Attachment G

Stakeholder Outreach and Responses

North Seneca Solar Project, LLC. (the Applicant) is proposing to construct and operate the North Seneca Solar Project (the Facility), a solar energy project in the Towns of Junius and Waterloo, Seneca County, New York. The proposed Facility is subject to review under Chapter XVIII, Title 19 of New York Codes, Rules, and Regulations (NYCRR) Part 900 and Section 94-c of the New York State Executive Law (hereafter referred to as Section 94-c). Section 94-c §900-2.9 (4) requires that *"the applicant shall confer with municipal planning representatives, the Office, and where appropriate, OPRHP and/or APA in its selection of important or representative viewpoints."* Pursuant to this requirement, Environmental Design and Research, Landscape Architecture, Engineering and Environmental Services, D.P.C. (EDR), as a representative of the Applicant, has conferred with municipal planning representatives and state agencies to solicit comments and recommendations on visually sensitive resources (VSRs) in the vicinity of the Facility and locations that would be suitable for the development of photosimulations. This attachment includes the visual co

Figure 2. Visually Sensitive Resources and Viewshed Results

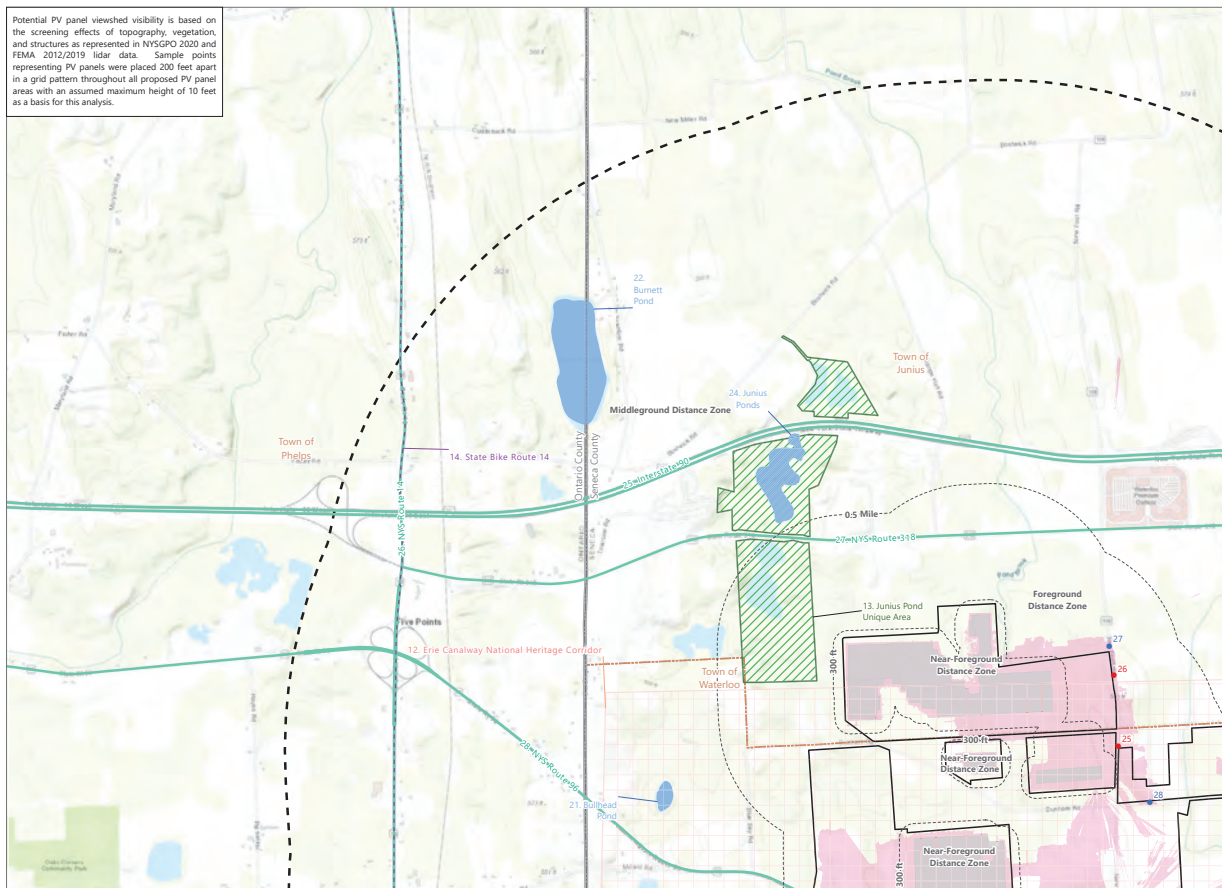
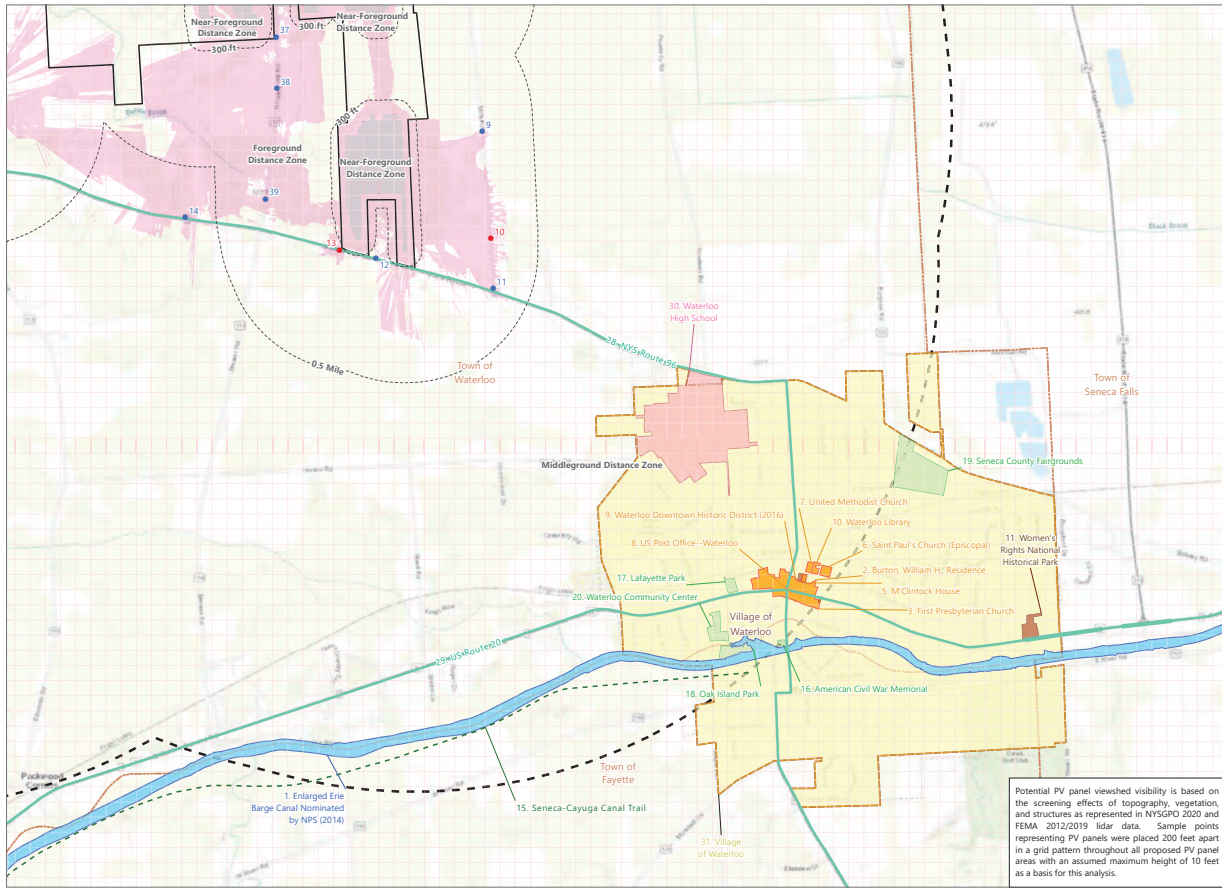
To help the Office assess a selection of important or representative viewpoints, please provide GIS shapefiles and a KMZ google earth file to correspond with Figure 2 Visually Sensitive Resources and Viewshed Results. Please include the proposed array locations, proposed fence line, panel visibility, 2 mile study area boundary, viewpoint (VP) locations, and label all visual resources as identified on Attachment C: Visually Sensitive Resource Table. **Noted, requested materials will be provided in a supplemental outreach submission following clarifications on visually sensitive resources requests.**

Attachment A: Figure 2: Visual Sensitive Resources and Viewshed, please include: **As described in the letter, the visually sensitive resources identified for this study will be based upon the "designated scenic resources, areas or features" categories identified in subsection 900-2.9(b)(4)(ii) of the 94-c regulations. In addition, we also included a few other categories of aesthetic resources identified in DEC visual policy (DEP-00-02 Assessing and Mitigating Visual and Aesthetic Impacts).**
